APPENDIX A

Re: Responses to Commitments 1, 2, 7, and 8 from April 12, 2011, Technical Meeting

Per your request, we are responding to the above-noted commitments which were made during the Prairie Creek Mine – Canadian Zinc Corporation Technical Meeting held in Yellowknife on April 12, 2011. This is a subset of the commitments which are listed in the meeting summary report.

Figure 1: Time Series Plot of Annual Minimum Daily Flow
Prairie Creek at Cadillac Mine

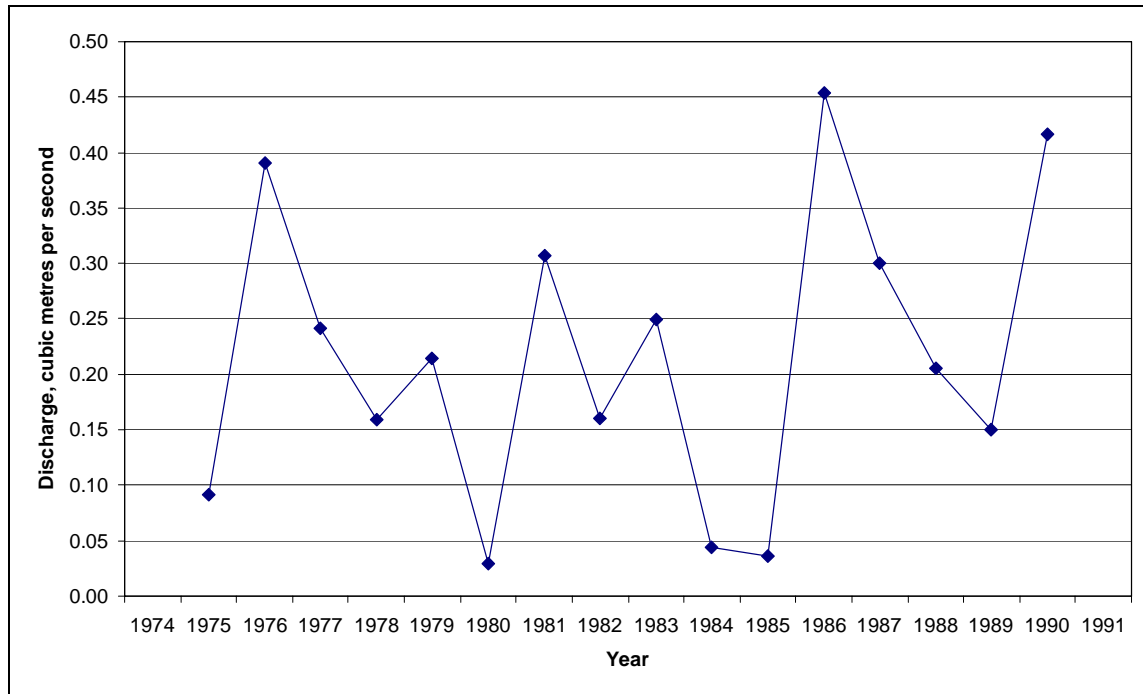
Commitment Item 2: Analysis of the likelihood of the return period for the documented 1 in 16 year Prairie Creek low flow.

Response. A low flow analysis was made on the 16 years of Water Survey of Canada streamflow data for Prairie Creek at Cadillac Mine. This gauge was operated from 1975 through 1990. Figure 1 below presents a time series plot of the annual minimum daily flows. Figure 2 presents frequency analysis results for the same data.

In the 16 years of record, the annual minimum daily flow has ranged from 0.454 to 0.029 m³/s. There is no visually obvious trend with rising or declining flows over time. In three of the 16 years of record, flows have been extremely low, less than 0.05 m³/s, so it is apparent that very low flows are not uncommon.
